Office Action Summary

10/673,680

DOUBLER ET AL.

FIG. 14

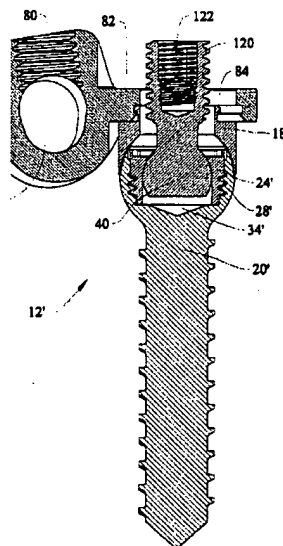
Claims 1-2, 9 and 15-16 are rejected under 35 U.S.C. 102(b) as being anticipated by Mullane (US 6,050,997). Mullane discloses a device for use in spinal fixation comprising a polyaxial bone screw (Fig. 2) that is capable of engagement into bone with an effective amount of torque (via threads, note 26 in Fig. 2), and that has a second end that is adapted for swivelable attachment to a linking member (Fig. 3, 32). Mullane further discloses a connecting member (82), and a portion that is capable of function as linear fastener. See Drawing of Fig. 14 below. The linear fastener also would fixedly engage about the linking member end to produce a clamping force.

In addition to the bone screw of Fig. 2 having a substantially spherical second end (opposite the threaded portion), Mullane also discloses a support collar (18), with a substantially spherical first surface and a generally flat second surface both of which aid

in providing a clamping force for locking the linking element. See Fig. 14 above. Mullane further discloses a collet member (24') with a tapered inner compression surface (see Fig. 14 above), and also a linking member tensioning means that has an internal bore with threads (122) that is capable being gripped by a threaded attachment to provide the necessary tensile force with respect to the collet.
